DATE	REVISION
7/30/21	90% CITY REVIEW
3/19/22	100% PERMITTING SUBMITTAL
7/11/22	ADDENDUM NO 2 GDOT ENTRANCE

FLOWERY BRANCH WRF EXPANSION
 CITY OF FLOWERY BRANCH, GA
 GA D.O.T. ENTRANCE
 SITE PLAN AND STAKING

FLOWERY BRANCH WRF EXPANSION
CITY OF FLOWERY BRANCH, GA
GA D.O.T. ENTRANCE
GRADING AND DRAINAGE

FLOWERY BRANCH WRF
UPGRADE TO 2.2 MGD

PACKAGED BOOSTER PUMP STATION DEMOLITION PLAN
3/8" = 1'-0"

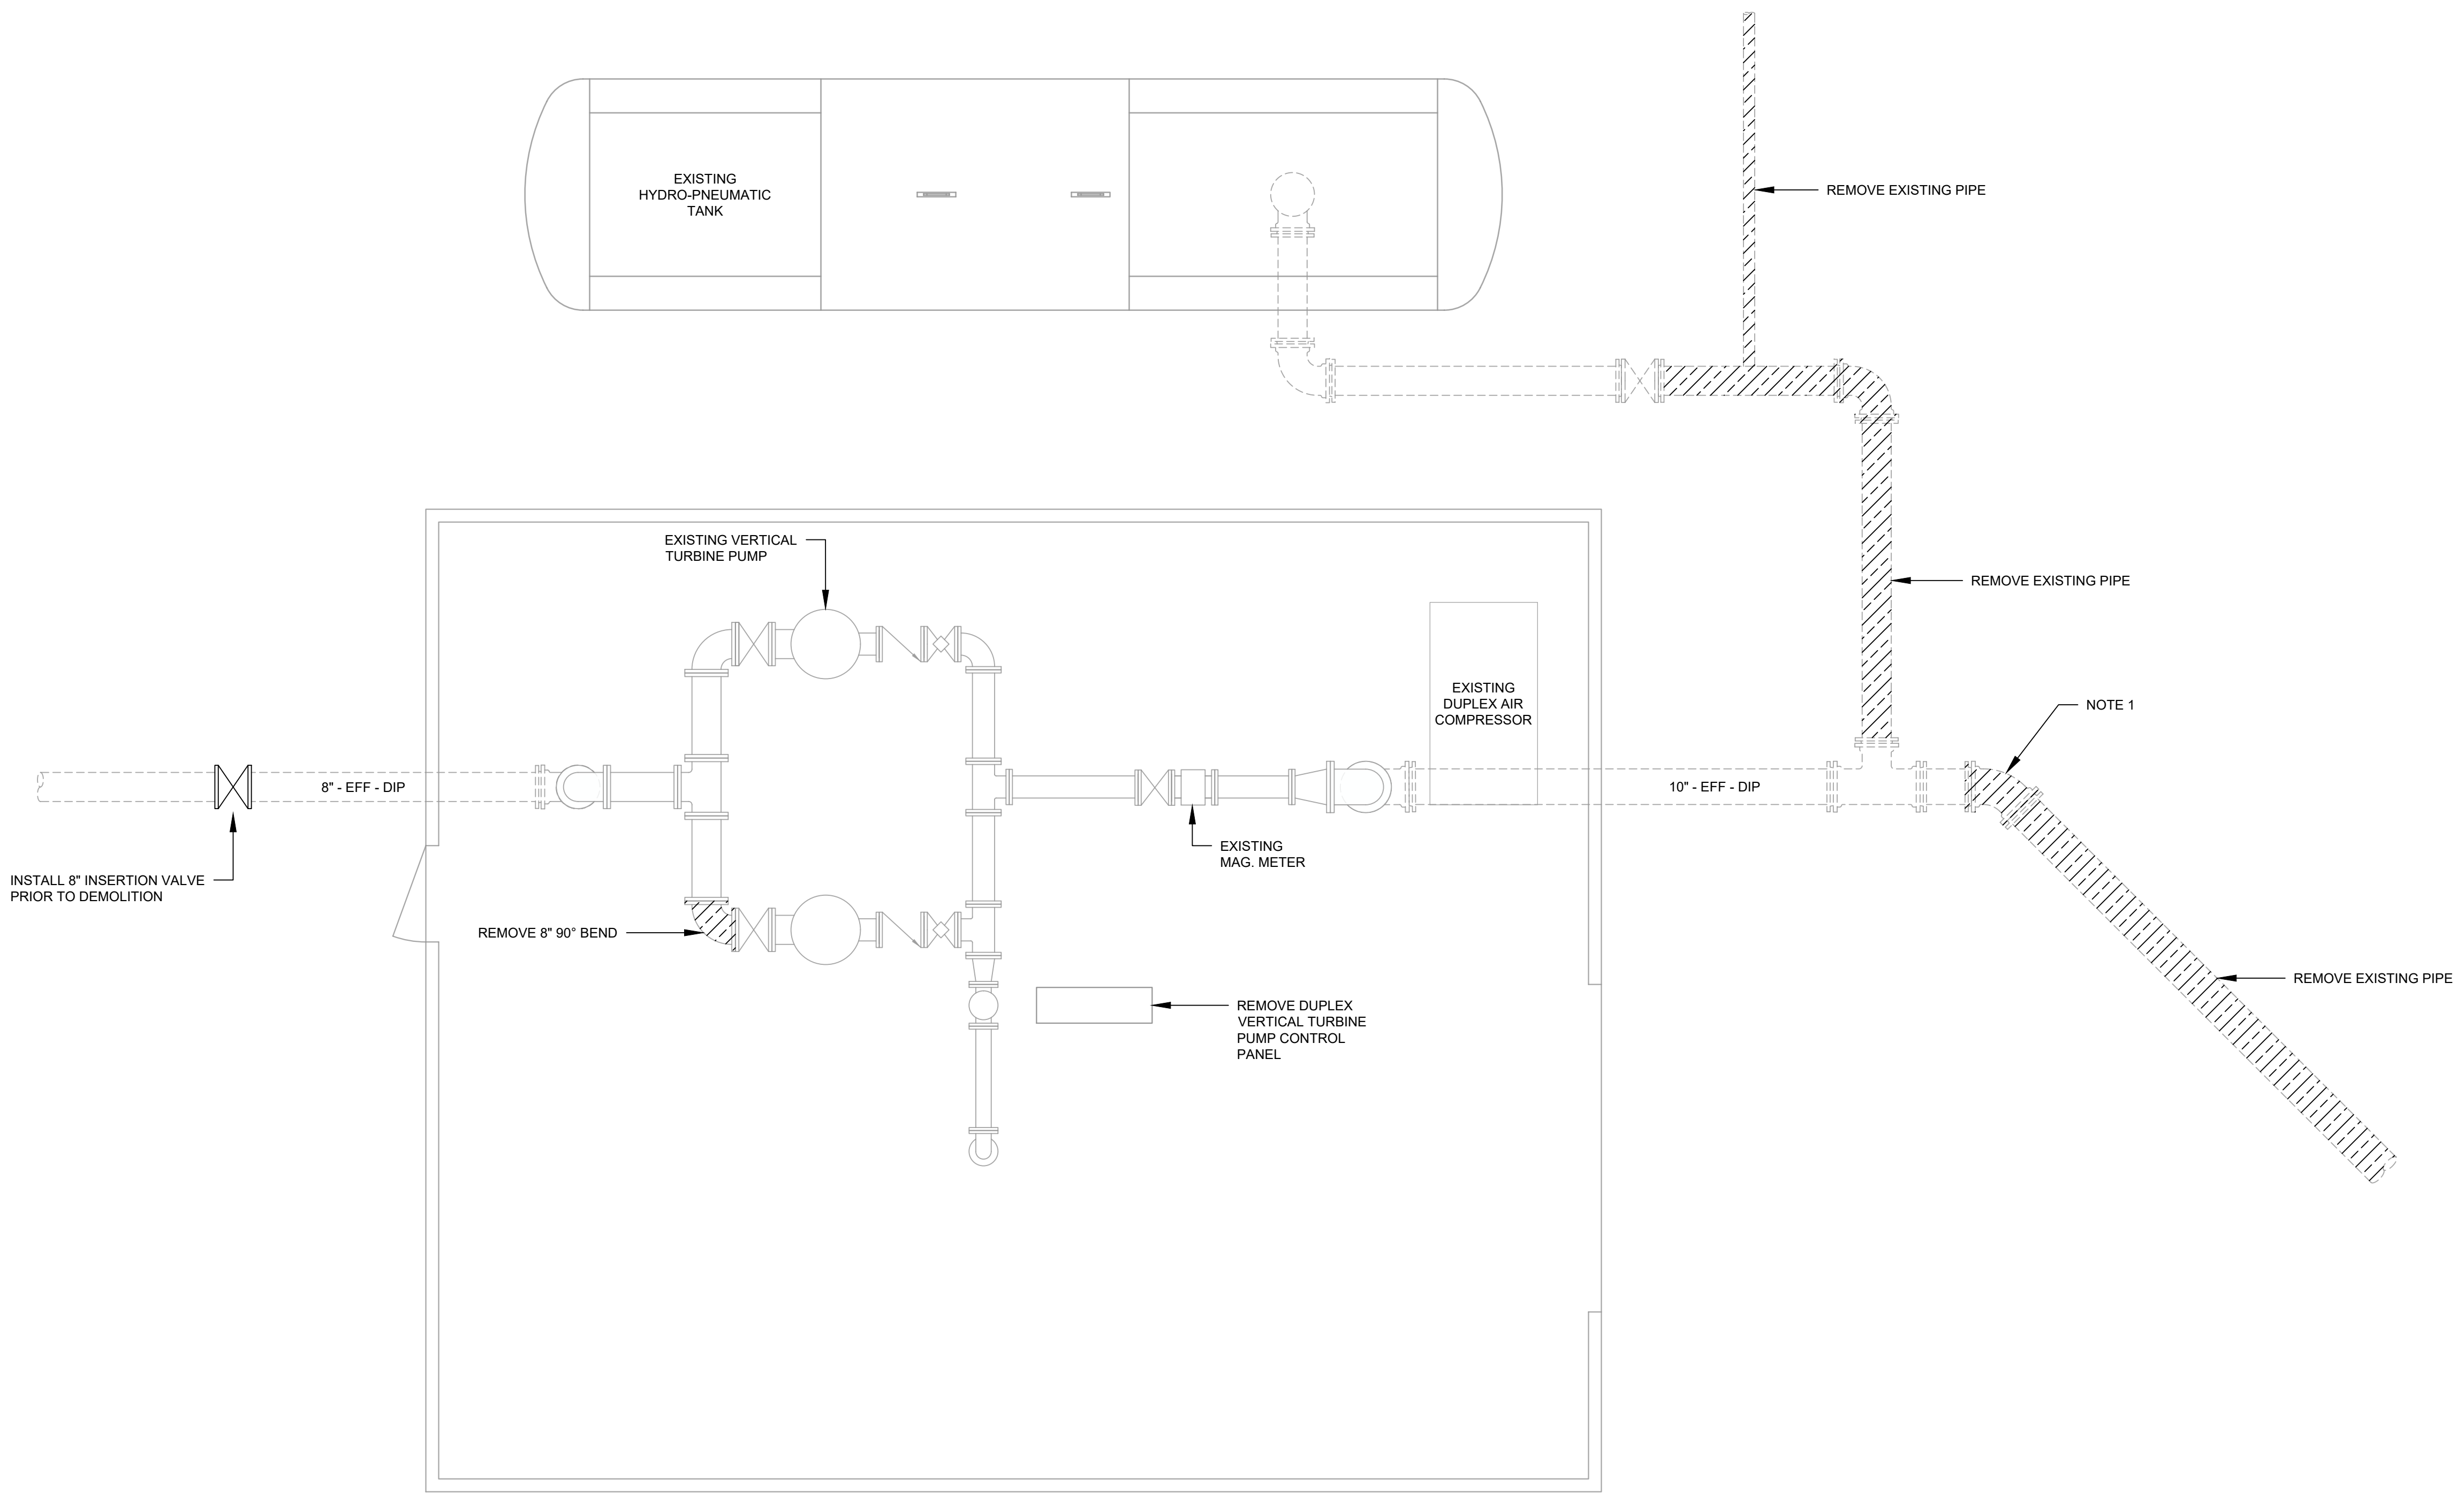
- NOTES:
1. ACTUAL PIPING ARRANGEMENT IS UNKNOWN. CONTRACTOR SHALL PERFORM AN EXPLORATORY EXCAVATION TO VERIFY PIPING ARRANGEMENT AND SIZE AND PROVIDE FITTINGS AND APPURTENANCES, AS REQUIRED, TO RECONFIGURE AND REROUTE PIPING.
 2. CONTRACTOR SHALL REMOVE SHELVING AND APPURTENANCES, AS REQUIRED FOR NEW BOOSTER PUMP STATION AND PIPING.
